Product change notification (PCN)

Title / short description	Changes to the cable duct portfolio
Affected article category	Installation and mounting material
Change category	Form and appearance
Change number	CBE230123-00
Reason for PCN/PDN Revision

Change of product design & marking

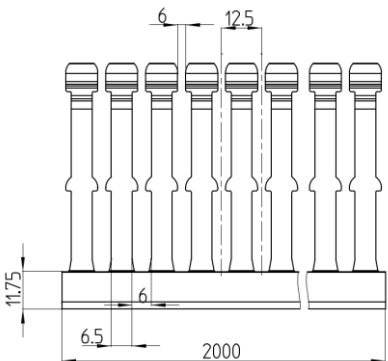
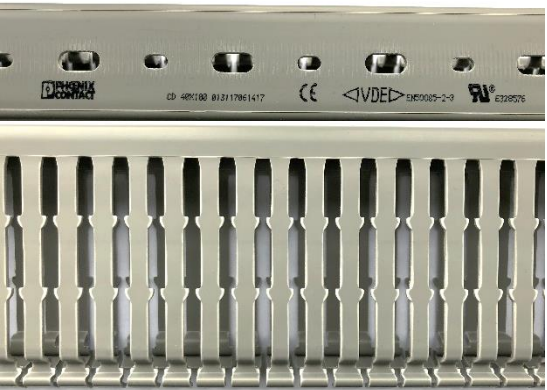
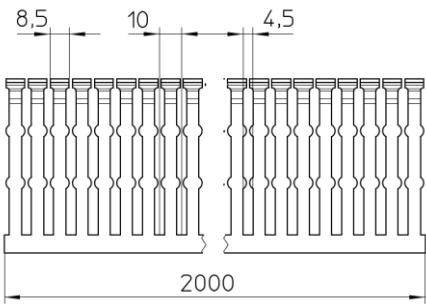
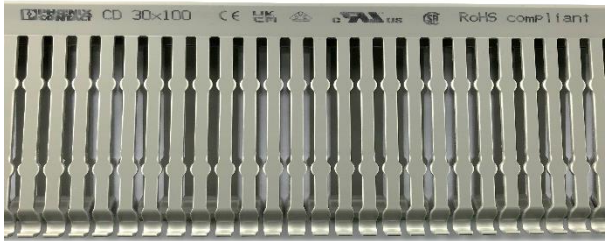
The cable ducts portfolio and its supply chain are strategically optimized in terms of design, packaging, resilience and sustainability. The redesign of the side punching and its predetermined breaking point allows removing the side punching manually in a more controlled manner. The outer dimensions, the color and the technical properties of the cable ducts remain unchanged. Thus, mixing the old and the new versions is possible. However, the covers of the old and new designs are not interchangeable.
